Addendum #1 - Issued on May 8, 2009

Regarding Bids for **Enterprise Network & Switching System - Multi-Purpose Arena (ITB 09-025P)** through Lucas County Administration, bid opening scheduled for May 13, 2009 at 2:00 PM (local time).

LUCAS COUNTY MULTI-PURPOSE ARENA
ENTERPRISE NETWORK AND SWITCHING SYSTEM

Lucas County Multi-Purpose Arena
Enterprise Network Routing and Switching System ITB 09-025P
Pre - Bid Questions (RFI)

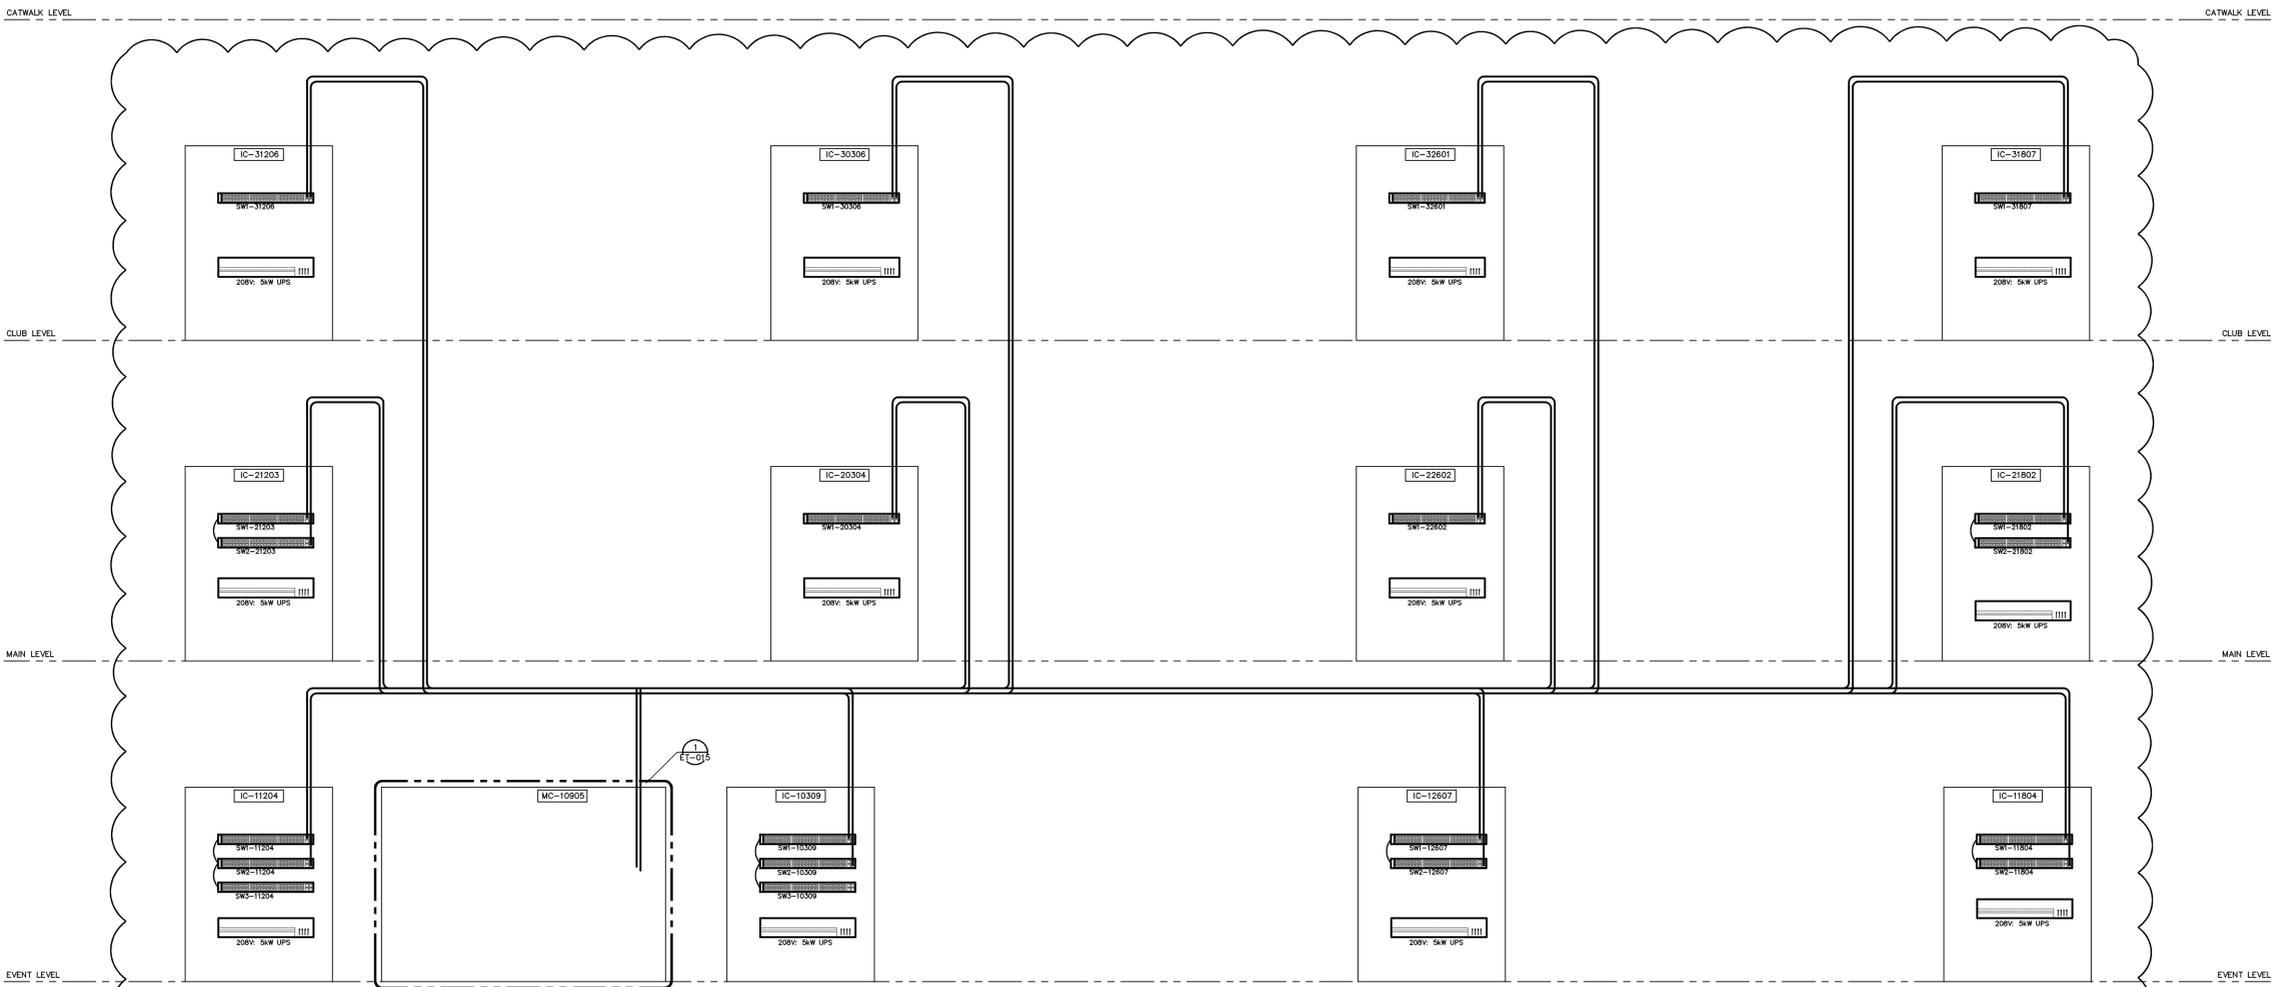
b.) Per bid spec the upgrades will not work on the Nexus platform without dual supervisors. Would you like to increase the supervisor count to (2) per chassis?

Two supervisor modules are required in a Cisco Nexus 7000 Series system for high availability with active standby redundancy, where one supervisor module is operationally active, and the standby device serves as a hot backup. Out-of-band access to both supervisors is available from either CMP."

Answer: *This is not a requirement, bid 1 supervisor per N7k.*
